DATAFILE BULLETIN

FILE UNDER: Receivers
ER-42-B
BULLETIN NO: 1086-1
DATE: March 1965

Equipment: 406—470 MC MASTR Progress Line Receivers

Fig. 1 - Old Circuit

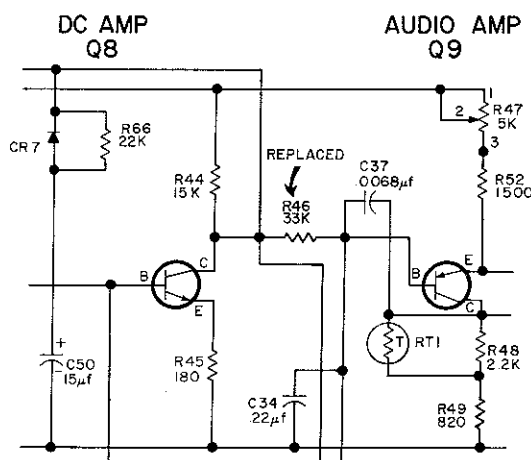
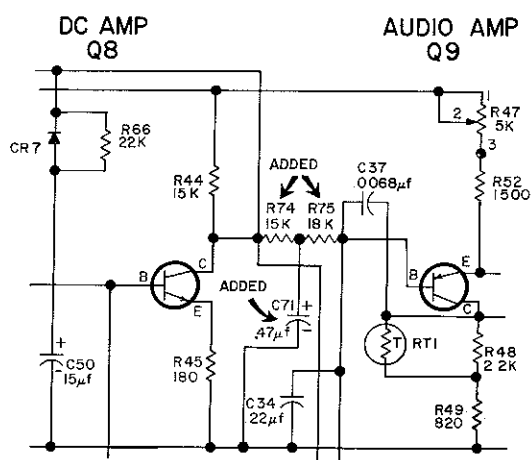
This revision provided decoupling between the output of the DC amplifier and the input of the first audio stage to reduce rumble at low volume settings. Resistor R46 was replaced by decoupling network R74-R75-C71 on the IF/Audio & Squelch Board.

Field Solution: If rumble is noticed at low volume settings, it can be eliminated by adding the decoupling network on the IF/Audio & Squelch Board as follows:

1. Remove R46 (33K ohms $\pm 10\%$, 1/2 watt) from the IF/Audio Board.
2. Mount R74 (15K ohms $\pm 10\%$, 1/2 watt) and R75 (18K ohms $\pm 10\%$, 1/2 watt) in the holes from which R46 was removed. See Figure 3.

Figure 1 - Showing Diode Added

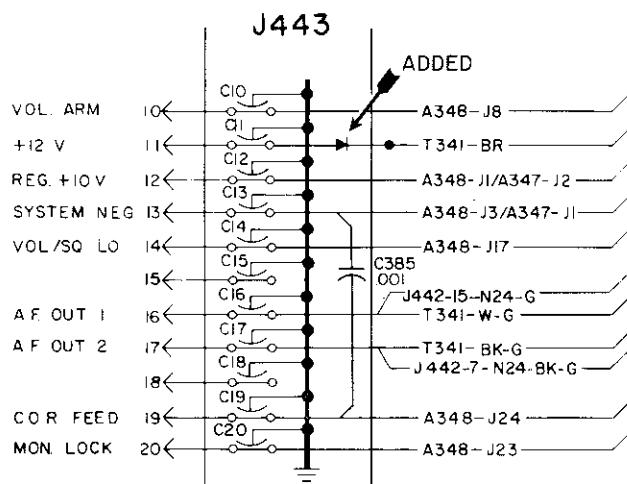
This revision added a diode in series with the +12 VDC supply lead to prevent negative spikes from reaching the output transistor. See Figure 1.

Field Solution: The diode should be added to receivers which do not have it, as shown in Figure 1. Connect the anode lead to J443-11 and the cathode lead to the brown wire from the audio output transformer. Use sleeving where necessary.

Fig. 1 - Before Modif.

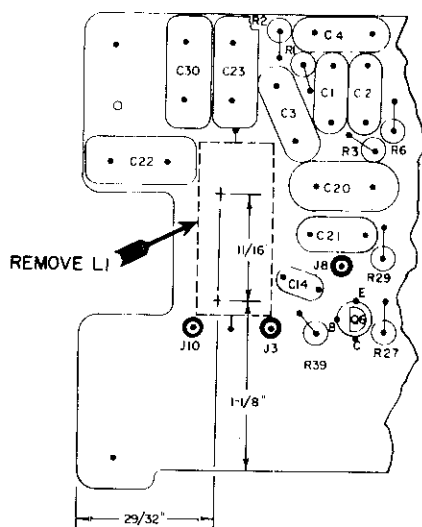
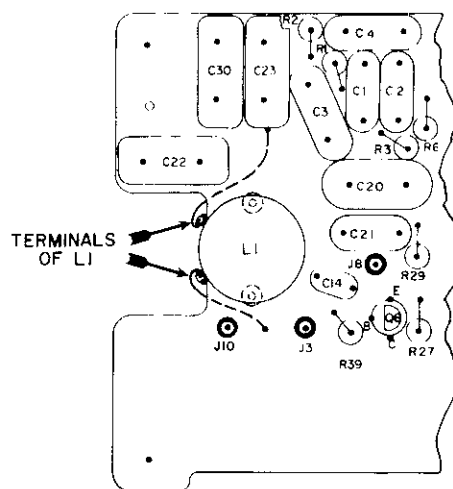
1. Remove and discard the tubular choke L1 (19A115690-P2).
2. Drill two 1/8" holes in the Channel Guard board at the locations shown in Figure 1.

3. Install eyelets in the two 1/8-inch holes.
4. Mount the new pot-core choke (19B204554-G1) in the eyelets so that the two terminals of the choke hang over the edge of the board. See Figure 2.
5. Using sleeved #22 bus wire, connect the choke terminals to the holes from which the old choke was removed.
6. Remove and discard the bracket used to fasten the back cover to the receiver. Otherwise, L1 will hit the bracket when the receiver is reassembled.

FIG 1

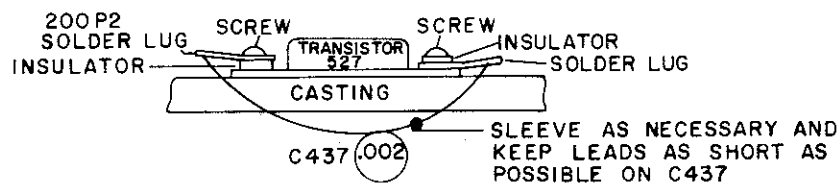
This revision added capacitor (C437) from collector of audio PA transistor (Q410) to ground and eliminated the instability.

1. Solder C437 in circuit as shown in Fig. 1.
2. Stamp or mark unit with "Rev. C".

FIGURE 1

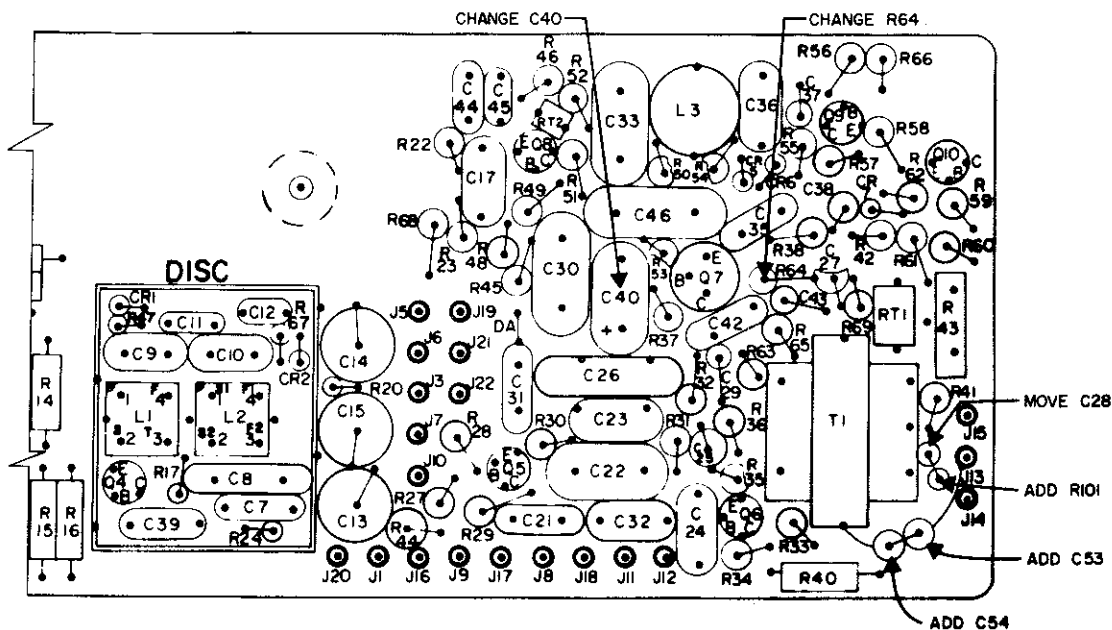
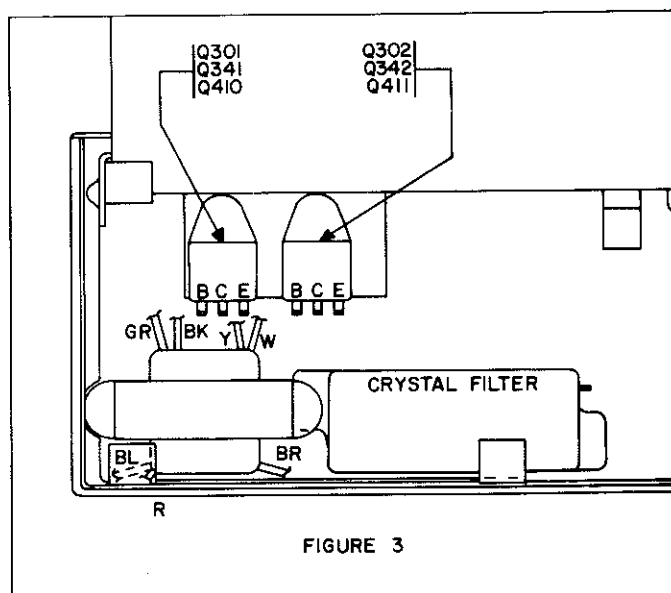
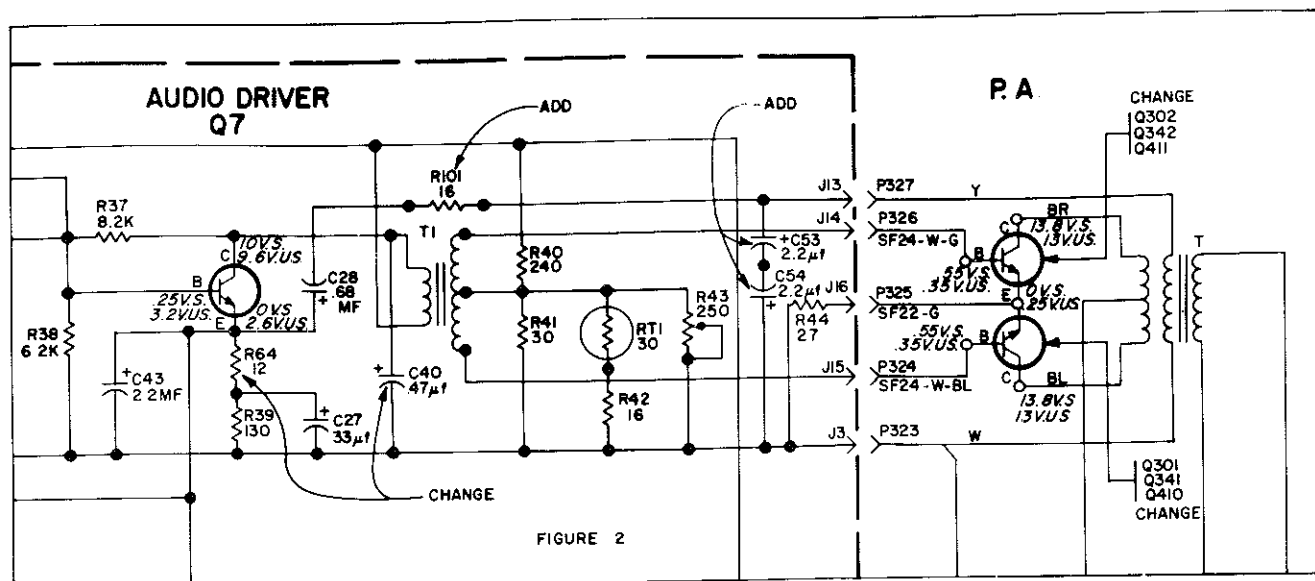
The 19A116203-P2 transistor can be used in place of the 19A115948-P1 but the following changes have to be made: (Refer to Figure 1, 2, & 3)

1. Change R64 from 18 ohms to 12 ohms.
2. Change C40 from 0.22 μ F to 0.47 μ F.
3. Add C53 and C54 (2.2 μ F) in series. Solder the can (Neg.) sides together. Connect the positive side of C53 to J13 pad and the positive side of C54 to system negative near T1.
4. Unsolder and carefully remove C28 (0.68 μ F). Solder the positive (+) side of C28 in the pad that connects to C43 & R64.
5. Solder one side of R101 (16 ohms) to the pad connecting J13. Solder the other side of R101 to the negative (-) side of C28.
6. Replace the two audio output transistors with 19A116203-P2. (see Fig. 3) Mount each transistor with a 19A116023-P2 insulator plate and a 19A116022-P1 bushing. Use silicon grease on both sides of the insulator plate.

7. TEST PROCEDURE CHANGE: Turn the squelch control fully counterclockwise. Connect a milliammeter in series with the +12 volt lead at P443-11. With no signal in, adjust the PA bias adjust (R43) for a reading of approximately 20 milliamps.
